March 5th, 2018

MCDJ Dual-rod Cylinder

Thank you for supporting Mindman products.
MCDJ Dual-rod Cylinder will have following changes.

3. Design change

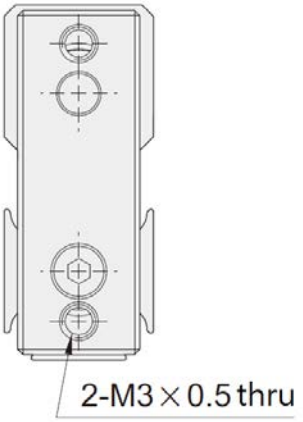
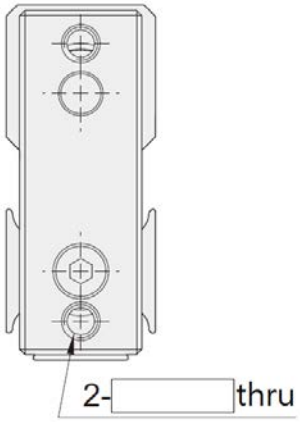
According to most of the feedback and suggestions from customers, we will change some of the mounting thread size. The affected dimensions are shown below.

Size	Thread
Ø6	M3x0.5
Ø10

Size	Thread
Ø6	M3x0.5
Ø10	M4x0.7
